June 28, 2002

AEP:NRC:2606  
10 CFR 50.54(f)

Donald C. Cook Nuclear Plant Units 1 and 2  
GENERIC LETTER 96-06  
ASSURANCE OF EQUIPMENT OPERABILITY AND CONTAINMENT  
INTEGRITY DURING DESIGN-BASIS ACCIDENT CONDITIONS  
REQUEST FOR ADDITIONAL INFORMATION  
(TAC NOS. M96801 and M96802)

### RESPONSE TO GENERIC LETTER 96-06 REQUEST FOR ADDITIONAL INFORMATION

Figure 1

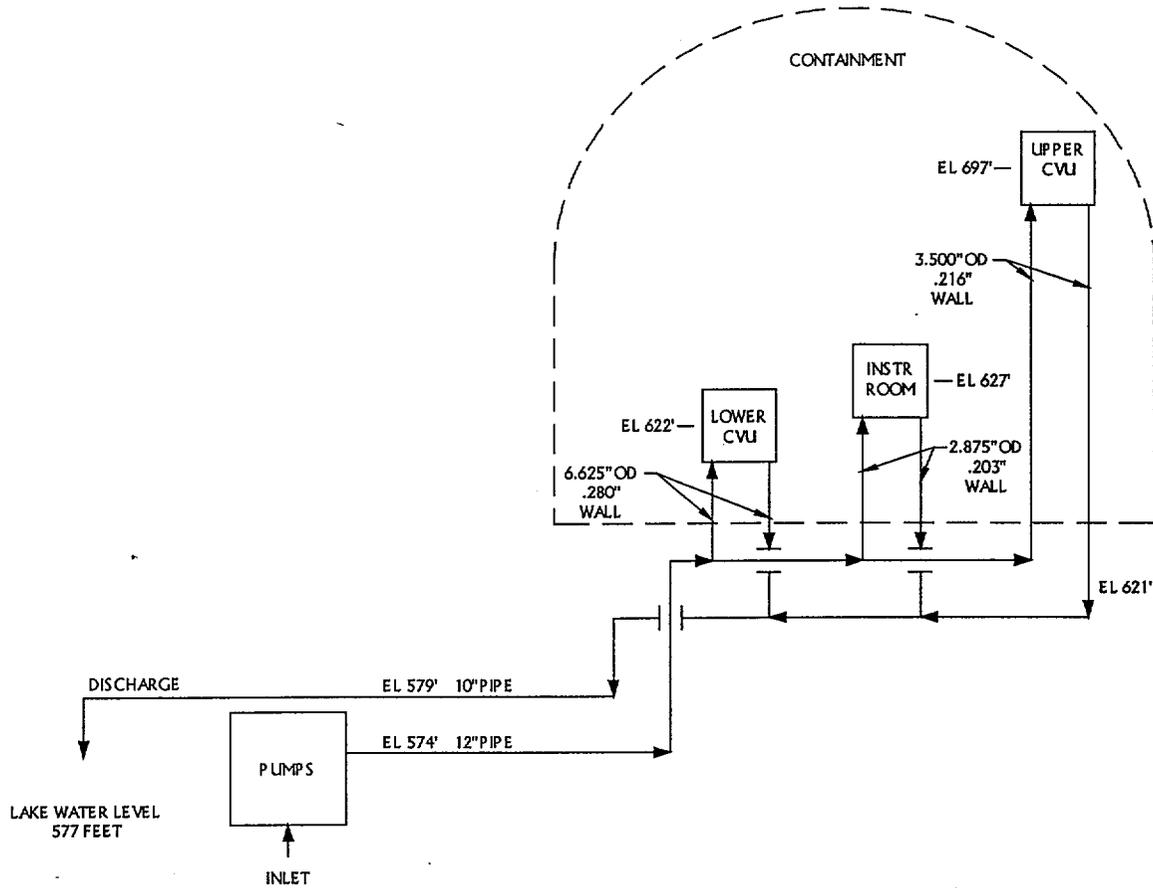
*Provide a simplified diagram of the fan cooler system showing the piping areas, elevations, and flow velocities at the time before the calculated waterhammer occurs. This will allow the NRC staff to perform its own calculation using the Joukowski equation.*

The non-essential service water (NESW) system at the Donald C. Cook Nuclear Plant is a once-through cooling system that takes suction from the plant forebay (directly supplied by Lake Michigan), pumps the water through heat exchangers that cool plant components, and returns the water back to the lake. Figure 1 is a simplified schematic of the NESW system as modeled for the transient analysis associated with a loss of offsite power.

The primary heat loads on the NESW system inside containment that are not isolated following a LOOP are the containment ventilation units (four lower and four upper), and two instrument room ventilation units.

The elevation of the lower containment ventilation units is 45 feet above Lake Michigan mean low water level and the elevation of the upper containment ventilation units is 120 feet above Lake Michigan mean low water level. Consequently, the water will start to drain from the system when power to the pumps is lost, starting with the higher

**Figure 6**

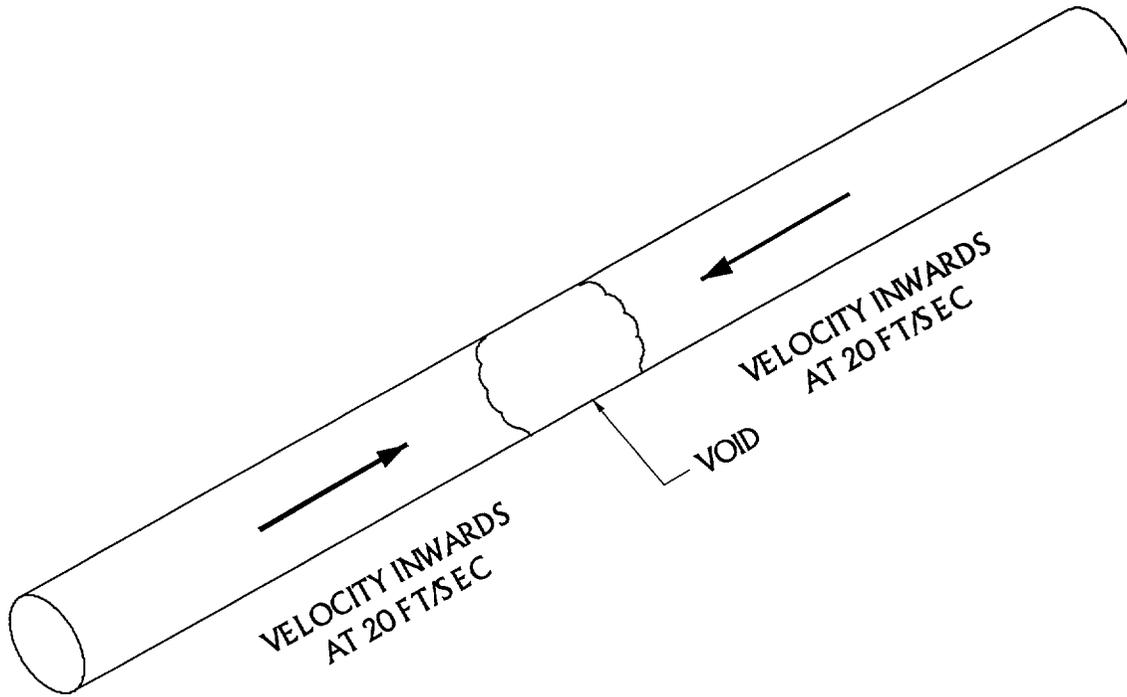
*Provide a comparison of predictions by the SYSFLO code with predictions of the Joukowski equation for waterhammer pressure pulse.*

A simple sample analysis using the SYSFLO computer program was conducted to determine the pressure response of two water columns impacting at a void. A simple straight horizontal pipe with a void at the center and increased pressure at the ends was used for the analysis. Pressure boundaries at the ends of the pipe cause the flow to accelerate towards the void and the water columns impact against each other as the void

disappears to generate the waterhammer. The schematic in Figure 6 shows the conditions in the pipe prior to the void collapse.
